TECHNICAL MEMORANDUM #5a

Pendleton IAMPs: Exit 207 & Exit 210

Concepts Evaluation and Screening

Date: April 27, 2020 Project #: 24043

Table 1 – Concept 1A

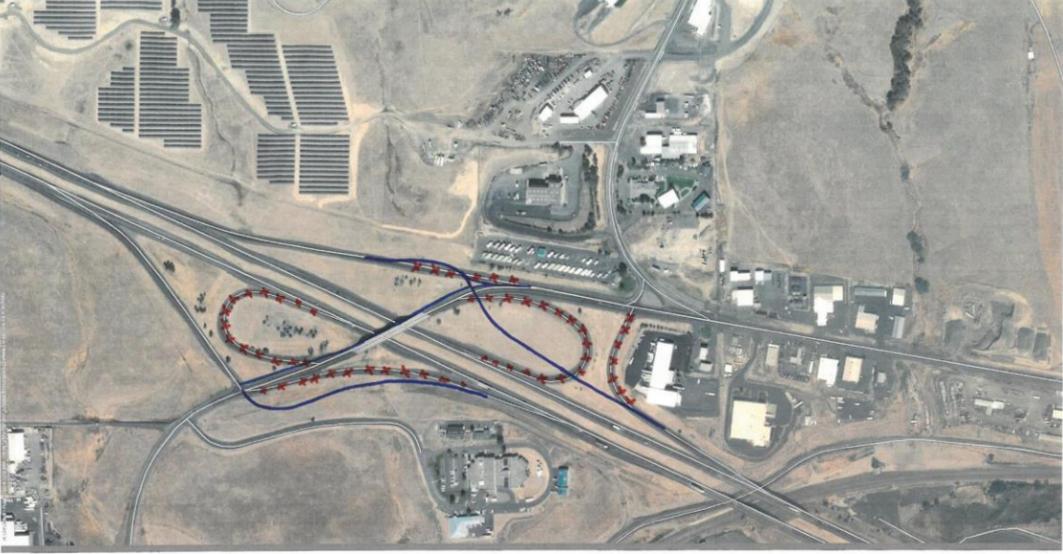
Exit 207 – Concept 1A		Evaluation Information			Evaluation Results		
Concept Description and Illustration		Category	Evaluation Criteria	Scoring Key	Score	Comments	
<p>This concept converts the existing interchange to a diamond interchange and widens the existing overpass structure to add-in a left-turn lane. This redesign would provide a simpler interchange form. Realigning the I-84 Westbound off-ramp will reduce the potential for slide-offs during the winter and improve access spacing to Airport Road and private accesses along US 30, thereby reducing conflicts in the interchange area. Removing the free-right-turns will also reduce conflicts for people walking through the area.</p>	<p>1 A</p> 	Transportation	Addresses the identified operational and safety concerns at the interchange: 1) Location of Airport Road across from I-84 WB off-ramp 2) Slide-offs along the I-84 WB off-ramp"	+1	Addresses both identified concerns	+1	The existing WB off ramp is relocated further to the west. This addresses the existing geometric slide-off deficiencies and eliminates the connection across from Airport Road.

0	Addresses only one identified concern		
				-1	Does not address concerns and/or introduces new concerns		
			Improves walking and biking access	+1	Improves walking and biking in the study area for both ramps	+1	This concept eliminates the free-flowing right-turn movements at the ramp terminals, improving pedestrian comfort and visibility. A widened overpass would allow for the construction of new sidewalks.
				0	Improves walking and biking in the study area for one ramp		
				-1	Does not improve walking or biking in the study area		
	Land Use/ Economic Development	Accommodates future growth and minimizes right-of-way impacts	+1	Alternative provides for long-term growth in the study area with minimal ROW impacts	+1	The diamond interchange and associated widening of the overpass structure can accommodate long-term growth. The right-of-way impacts to private property are expected to be minimal.

-1	Alternative precludes long-term growth or has significant ROW impacts			
	Accessibility	Moves in the direction of ODOT access spacing requirements	+1	Moves in the direction of ODOT's access spacing guidelines	+1	This alternative moves the WB ramp terminal further to the west, thereby increasing the spacing distance to Airport Road and other private accesses along Highway 30.	
			-1	Does not move in the direction of ODOT's access spacing guidelines			
Cost	Cost relative to other concepts	+1	Low construction costs				
		0	Moderate construction costs				
		-1	Substantial construction costs	-1	The costs associated with widening the overpass and modifying the ramp terminals would be substantial.		
Implementation	Constructability	+1	Project can be constructed with relative ease and/or can maintain existing traffic during construction.				
		-1	Construction of improvements will be a physical challenge and/or will require major detours during construction.	-1	The existing overpass likely cannot be widened based on its current form. A separate parallel structure would need to be constructed in order to accommodate the extra width for a center turn lane.

2		
On-line Public Feedback & Miscellaneous Evaluation Comments							
General support for the diamond reconfiguration for its simplicity and addressing identified safety concerns							
Some concern about cost of structure modifications and whether all of this is necessary							
Need to verify adequate acceleration/deceleration is provided on the ramps							
Why modify the EB ramp configurations? They are adequately addressing existing interchange volumes							
Next Steps		Justification					
Do not move forward for further evaluation.		While this concept scored well on the whole, it is a major reconstruction of the entire interchange. There is not enough evidence that the EB ramp terminals need to be completely modified.

Table 3 – Concept 1C

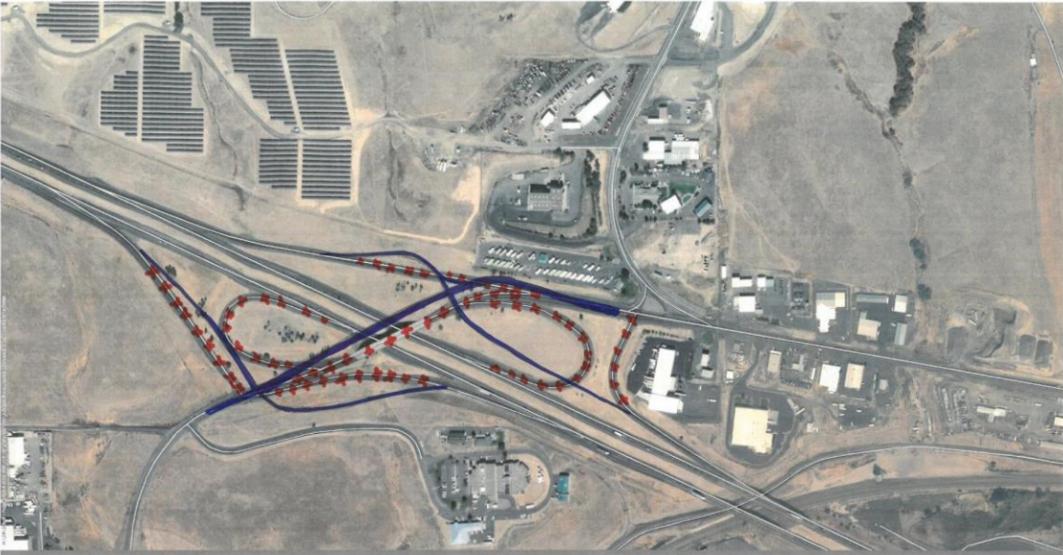
Exit 207 – Concept 1C		Evaluation Information			Evaluation Results		
Concept Description and Illustration		Category	Evaluation Criteria	Scoring Key	Score	Comments	
<p>This concept constructs a new diamond interchange and a new overpass structure. This redesign would provide a simpler interchange form. Realigning the I-84 Westbound off-ramp will reduce the potential for slide-offs during the winter and improve access spacing to Airport Road and private accesses along US 30, thereby reducing conflicts in the interchange area. Removing the free-right-turns will also reduce conflicts for people walking through the area.</p>  <p>1C</p> <p><small>KITTELSON & ASSOCIATES</small></p>		Transportation	Addresses the identified operational and safety concerns at the interchange: 1) Location of Airport Road across from I-84 WB off-ramp 2) Slide-offs along the I-84 WB off-ramp"	+1	Addresses both identified concerns	+1	The existing WB off ramp is relocated further to the west. This addresses the existing geometric slide-off deficiencies and eliminates the connection across from Airport Road.

0	Addresses only one identified concern		
				-1	Does not address concerns and/or introduces new concerns		
			Improves walking and biking access	+1	Improves walking and biking in the study area for both ramps	+1	Like Concept #1A, this design eliminates the free-flowing right-turn movements at the ramp terminals, improving pedestrian comfort and visibility.
				0	Improves walking and biking in the study area for one ramp		
				-1	Does not improve walking or biking in the study area		
		Land Use/ Economic Development	Accommodates future growth and minimizes right-of-way impacts	+1	Alternative provides for long-term growth in the study area with minimal ROW impacts	+1	The diamond interchange and new overpass can accommodate long-term growth. The right-of-way impacts to private property are expected to be minimal.
				-1	Alternative precludes long-term growth or has significant ROW impacts		
		Accessibility	Moves in the direction of ODOT access spacing requirements	+1	Moves in the direction of ODOT's access spacing guidelines	+1	This alternative moves the WB ramp terminal further to the west, thereby increasing the spacing distance to Airport Road and other private accesses along Highway 30.

-1	Does not move in the direction of ODOT's access spacing guidelines		
Cost	Cost relative to other concepts	+1	Low construction costs				
		0	Moderate construction costs				
		-1	Substantial construction costs	-1	This option and the new parallel overpass is expected to have substantial construction costs.		
Implementation	Constructability	+1	Project can be constructed with relative ease and/or can maintain existing traffic during construction.				
		-1	Construction of improvements will be a physical challenge and/or will require major detours during construction.	-1	A new interchange overpass and new diamond ramps would be extremely difficult to construct while maintaining existing traffic flow through the interchange.		
					2		
On-line Public Feedback & Miscellaneous Evaluation Comments							
Similar comments as at 1A							
Next Steps		Justification					
Do not move forward for further evaluation.		Similar to 1A. Involves a complete rebuild of a functioning interchange.

Table 4 – Concept 2

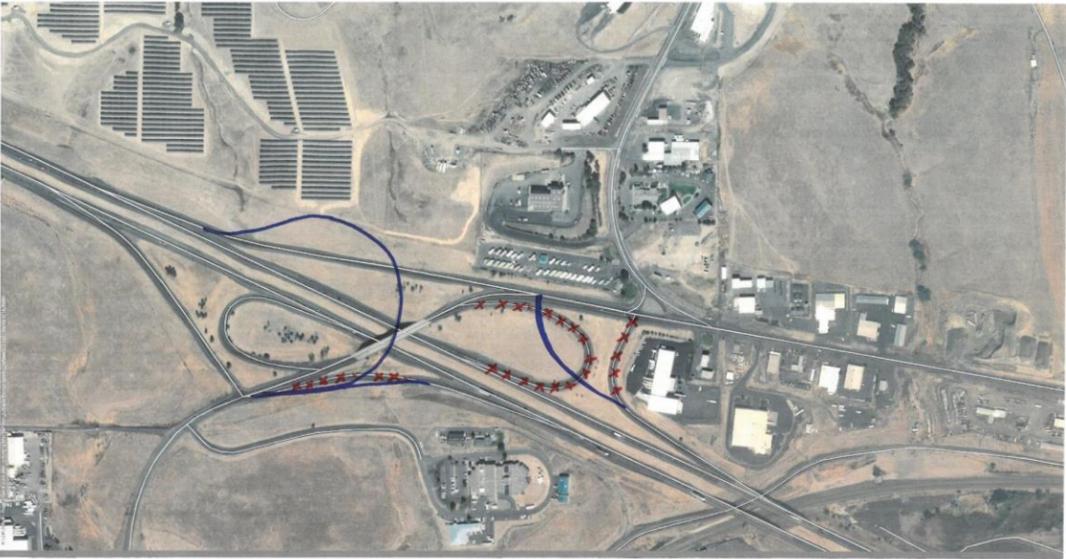
Exit 207 – Concept 2		Evaluation Information			Evaluation Results		
Concept Description and Illustration		Category	Evaluation Criteria	Scoring Key	Score	Comments	
<p>This concept constructs a flyover ramp and modifies the westbound ramps. Realigning the I-84 Westbound off-ramp will reduce the potential for slide-offs during the winter and improve access spacing to Airport Road and private accesses along US 30, thereby reducing conflicts in the interchange area. Removing the free-right-turns will also reduce conflicts for people walking through the area.</p>  <p>2</p> <p>KITTELSON & ASSOCIATES</p>		Transportation	Addresses the identified operational and safety concerns at the interchange: 1) Location of Airport Road across from I-84 WB off-ramp 2) Slide-offs along the I-84 WB off-ramp"	+1	Addresses both identified concerns	+1	The existing WB off ramp is relocated further to the west. This addresses the existing geometric slide-off deficiencies and eliminates the connection across from Airport Road.

0	Addresses only one identified concern		
				-1	Does not address concerns and/or introduces new concerns		
			Improves walking and biking access	+1	Improves walking and biking in the study area for both ramps		
				0	Improves walking and biking in the study area for one ramp		
				-1	Does not improve walking or biking in the study area	-1	There are minimal improvements to the walking or biking environment.
		Land Use/ Economic Development	Accommodates future growth and minimizes right-of-way impacts	+1	Alternative provides for long-term growth in the study area with minimal ROW impacts	+1	The fly-over is anticipated to provide for long-term growth in the study area. The right-of-way impacts to private property are expected to be minimal.
				-1	Alternative precludes long-term growth or has significant ROW impacts		
		Accessibility	Moves in the direction of ODOT access spacing requirements	+1	Moves in the direction of ODOT's access spacing guidelines	+1	This alternative moves the WB ramp terminal further to the west, thereby increasing the spacing distance to Airport Road and other private accesses along Highway 30. Compared to the other evaluated concepts, this improved access spacing is not as significant.

-1	Does not move in the direction of ODOT's access spacing guidelines		
Cost	Cost relative to other concepts	+1	Low construction costs				
		0	Moderate construction costs				
		-1	Substantial construction costs	-1	The construction of a fly-over ramp is anticipated to have substantial construction costs. Further, the eastbound left-turn volumes do not warrant such a massive and costly structure.		
Implementation	Constructability	+1	Project can be constructed with relative ease and/or can maintain existing traffic during construction.				
		-1	Construction of improvements will be a physical challenge and/or will require major detours during construction.	-1	The construction of a fly-over ramp will be an engineering challenge while maintaining existing traffic flow.		
					0		
On-line Public Feedback & Miscellaneous Evaluation Comments							
Like the relocation of the WB off-ramp.							
Concern about the cost of the concept, especially relative to others and whether the flyover may result in wintertime slide issues.

Next Steps		Justification					
Do not move forward for further evaluation.		Flyover ramp is not necessary nor proportionate to the interchange volumes.

Table 5 – Concept 3

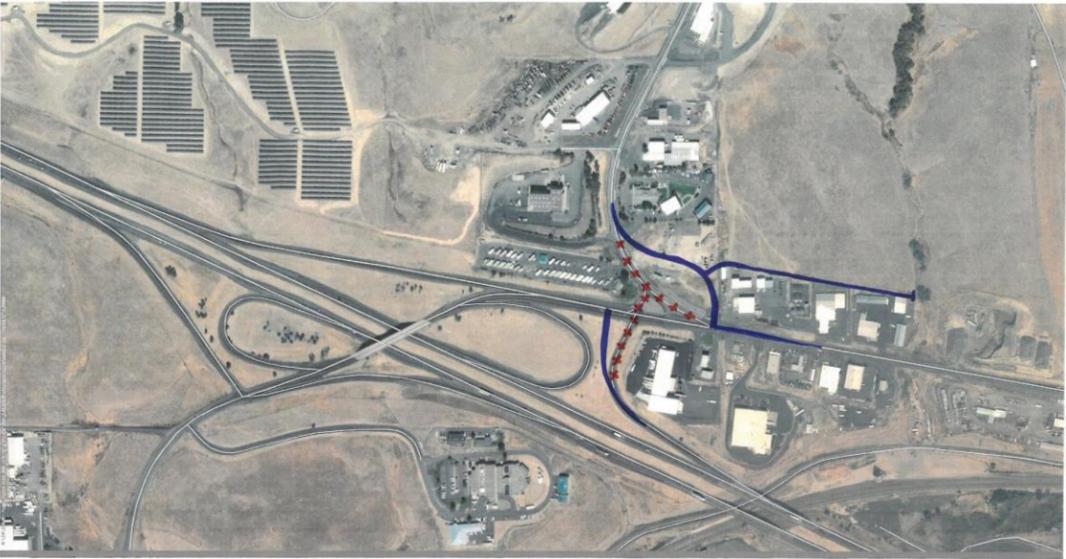
Exit 207 – Concept 3		Evaluation Information			Evaluation Results		
Concept Description and Illustration		Category	Evaluation Criteria	Scoring Key	Score	Comments	
<p>This concept provides minimal changes to the interchange. It realigns the I-84 Westbound off-ramp to reduce the potential for slide-offs during the winter and improve access spacing to Airport Road and private accesses along US 30, thereby reducing conflicts in the interchange area. It also realigns Airport Road to provide more spacing between Airport Road and the I-84 Westbound off-ramp. It creates a new access road behind businesses along the northside of US 30 (Westgate) so that they can take access from that road instead of US 30; thereby reducing the number of accesses within ¼-mile of the I-84 interchange.</p>  <p>3</p> <p>KITTELSON & ASSOCIATES</p>		Transportation	Addresses the identified operational and safety concerns at the interchange: 1) Location of Airport Road across from I-84 WB off-ramp 2) Slide-offs along the I-84 WB off-ramp"	+1	Addresses both identified concerns	+1	The existing WB off ramp is relocated slightly to the west and the Airport Road intersection is relocated slightly to the east. This addresses the existing geometric slide-off deficiencies and eliminates the connection across from Airport Road.

0	Addresses only one identified concern		
				-1	Does not address concerns and/or introduces new concerns		
			Improves walking and biking access	+1	Improves walking and biking in the study area for both ramps		
				0	Improves walking and biking in the study area for one ramp		
				-1	Does not improve walking or biking in the study area	-1	Compared to Concepts #1A-#1C, this concept does not improve walking or biking conditions in the vicinity of the existing interchange ramps.
		Land Use/ Economic Development	Accommodates future growth and minimizes right-of-way impacts	+1	Alternative provides for long-term growth in the study area with minimal ROW impacts		
				-1	Alternative precludes long-term growth or has significant ROW impacts	-1	The backage road paralleling the north side of Highway 30 will require right-of-way acquisition. The Airport Road realignment may impact the OSP crime lab and/or the parking area.

Accessibility	Moves in the direction of ODOT access spacing requirements	+1	Moves in the direction of ODOT's access spacing guidelines	+1	This alternative moves the WB ramp terminal slightly to the west, thereby increasing the spacing distance to Airport Road and other private accesses along Highway 30. The backage road along the north side of Highway 30 would further improve access management.
				-1	Does not move in the direction of ODOT's access spacing guidelines		
		Cost	Cost relative to other concepts	+1	Low construction costs	+1	In comparison to other concepts, this option is less expensive.
				0	Moderate construction costs		
				-1	Substantial construction costs		
		Implementation	Constructability	+1	Project can be constructed with relative ease and/or can maintain existing traffic during construction.	+1	The entire project could be constructed while maintaining existing traffic flow between I-84 and Airport Road.

-1	Construction of improvements will be a physical challenge and/or will require major detours during construction.		
					2		
On-line Public Feedback & Miscellaneous Evaluation Comments							
Like the simplicity and that this may be the lowest cost option.							
New WB off-ramp should be designed to alleviate slide-off/winter start-up issues.							
Sight distance will need to be re-evaluated from the new WB off-ramp with respect to the curve to the west on US 30.							
Eliminates a local street across from the WB off-ramp, but creates one additional intersection in closer proximity to WB on ramp.							
Next Steps		Justification					
Move forward for further evaluation		Potentially the least costly option while addressing the primary issues at the interchange.

Table 8 – Concept 1

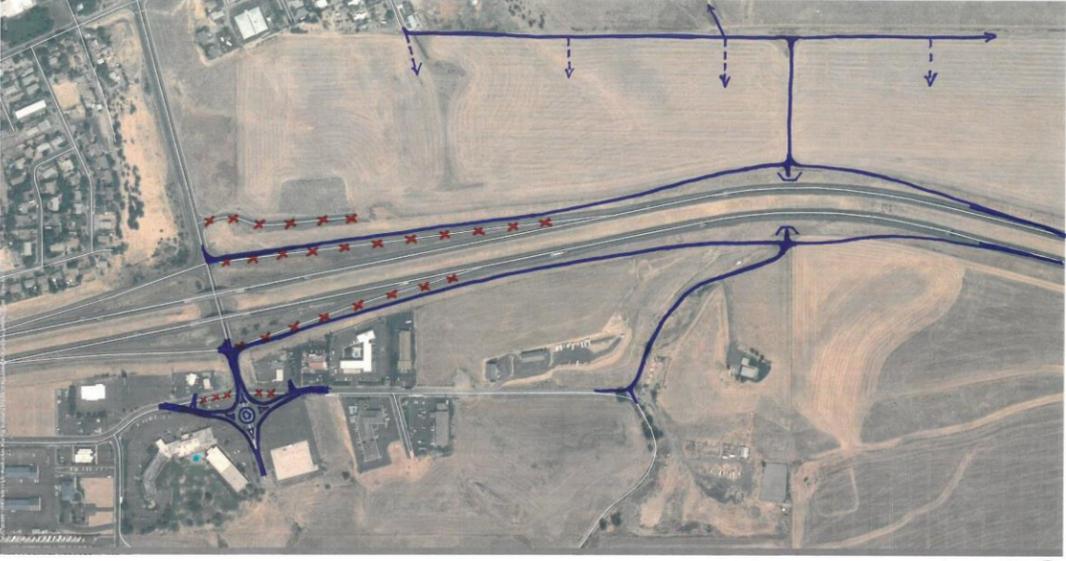
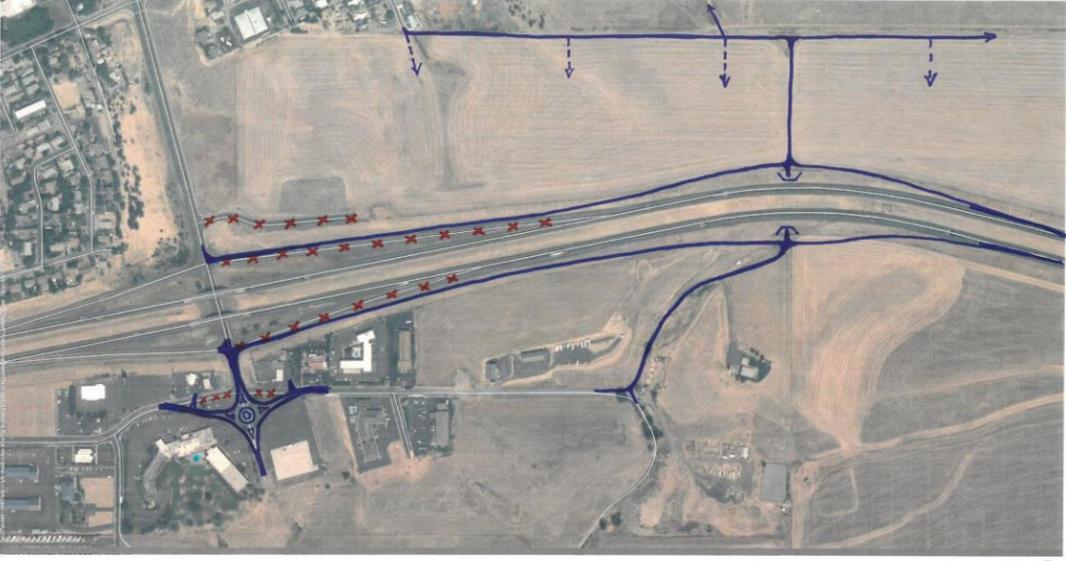
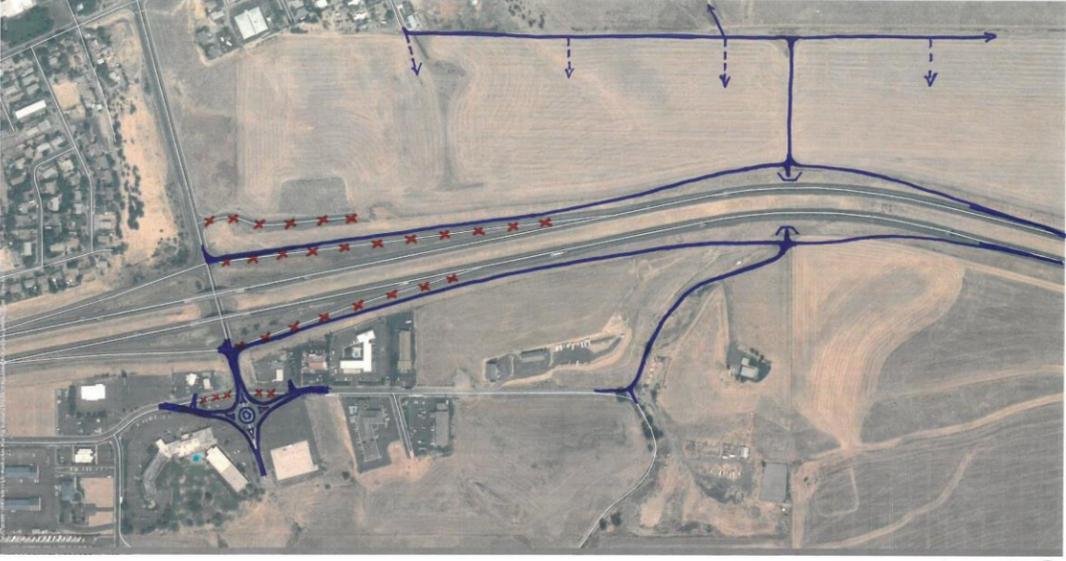
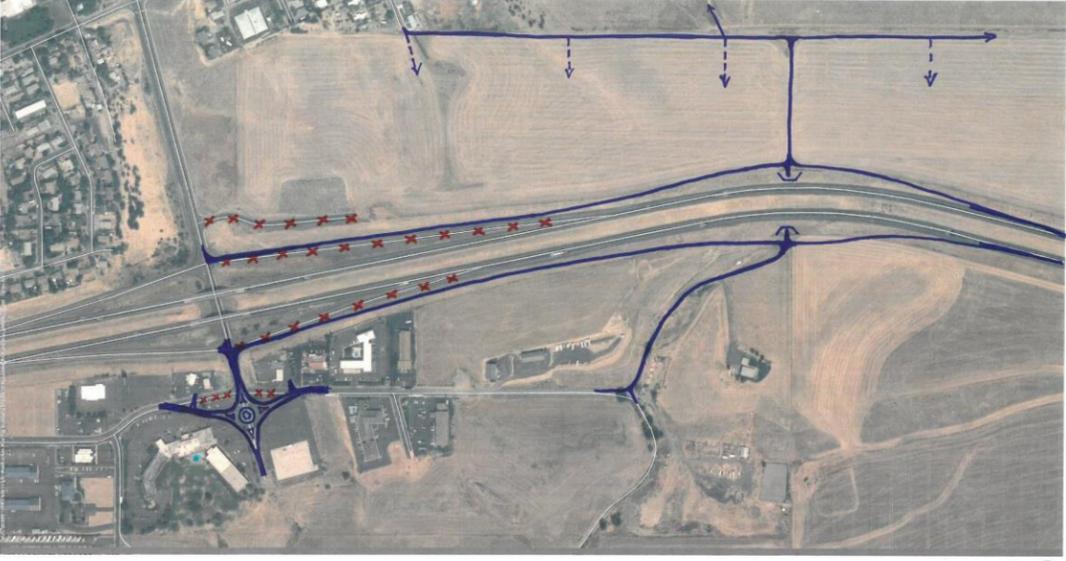
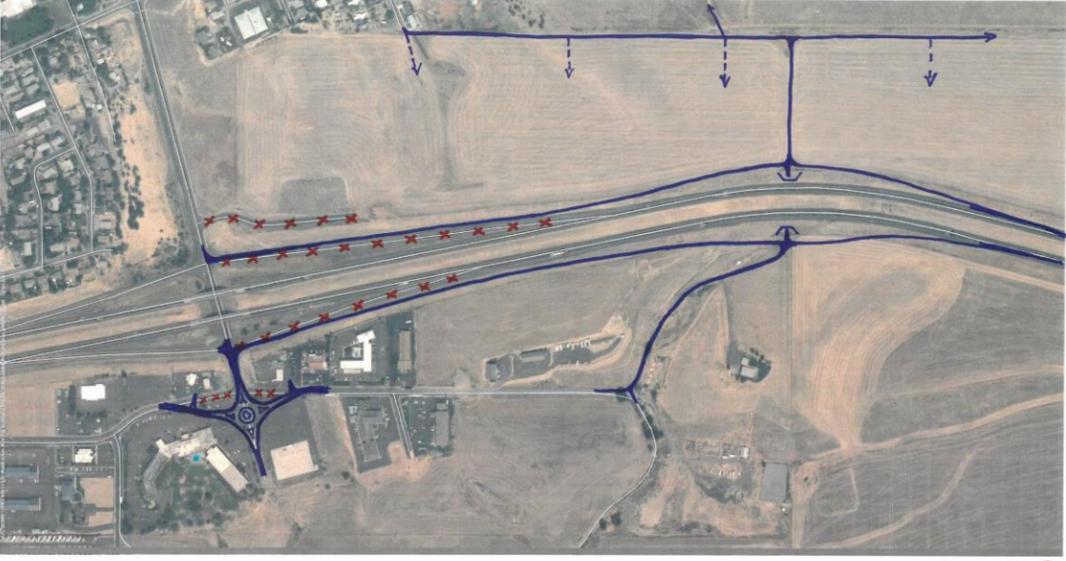
Exit 210 – Concept 1		Evaluation Information			Evaluation Results	
Concept Description and Illustration		Category	Evaluation Criteria	Scoring Key	Score	Comments
<p>This concept converts the existing interchange to a split diamond interchange in which the westbound off-ramp and the eastbound on-ramp would be further to the east (where Old Dump Road is). This would allow development and existing neighborhoods north of I-84 to take access from a new road connecting to the new on/off ramps. It also closes off Kirk Avenue, eliminating the close spacing from the westbound ramp terminal. This concept relocates Nye Avenue further away from the eastbound ramp terminal and uses a roundabout to improve circulation. These adjustments improve access spacing thereby reducing potential conflicts and improving the capacity of the roadways.</p>	Transportation	Addresses the limited intersection spacing between the WB ramp terminal and Kirk Avenue.	+1	Moves in the direction of ODOT's access spacing guidelines	+1	This concept closes off Kirk Avenue, eliminating the close spacing from the WB ramp terminal.

-1	Does not move in the direction of ODOT's access spacing guidelines		
	Transportation	Addresses the limited intersection spacing between the WB ramp terminal and Kirk Avenue.	+1	Moves in the direction of ODOT's access spacing guidelines	+1	This concept relocates Nye Avenue further away from the EB ramp terminal and utilizes a roundabout intersection form to improve circulation efficiency
			-1	Does not move in the direction of ODOT's access spacing guidelines		
	Land Use/ Economic Development	Accommodates future growth and minimizes right-of-way impacts	+1	Alternative provides for long-term growth in the study area with minimal ROW impacts		
			-1	Alternative precludes long-term growth or has significant ROW impacts	-1	There would be ROW impacts associated with a new interchange at Old Dump Road. The new circulation network serving the northeast quadrant would require ROW, but most of these impacts would affect currently undeveloped property. Some infrastructure would be located outside the current Pendleton UGB.

Accessibility	Moves in the direction of ODOT access spacing requirements	+1	Provides direct and efficient access to properties in the northeast quadrant of the interchange.	+1	The new split diamond interchange at Old Dump Road would provide direct access to the northeast quadrant of the interchange.
			-1	Provides indirect or inefficient access to properties in the northeast quadrant of the interchange.		
	Cost	Cost relative to other concepts	+1	Low construction costs		
			0	Moderate construction costs		
			-1	Substantial construction costs	-1	A new interchange underpass at Old Dump Road and the associated frontage roads would have substantial construction costs.
	Implementation	Constructability	+1	Project can be constructed with relative ease and/or can maintain existing traffic during construction.		
			-1	Construction of improvements will be a physical challenge and/or will require major detours during construction.	-1	While the majority of the split diamond interchange could be constructed while maintaining existing traffic, the scale of the project is comparatively large with many unknown complexities.

0	
On-line Public Feedback & Miscellaneous Evaluation Comments						
Like that it opens up access to property north of the interchange and provides a different access to the properties on the south side.						
Concern about roundabouts (in general, not just here) and about closing Kirk Avenue.						
Concern that access to north side from the north would be confusing/out-of-direction for potential customers.						
Next Steps		Justification				
Move forward for further evaluation.		Third highest score. Supported by survey respondents.
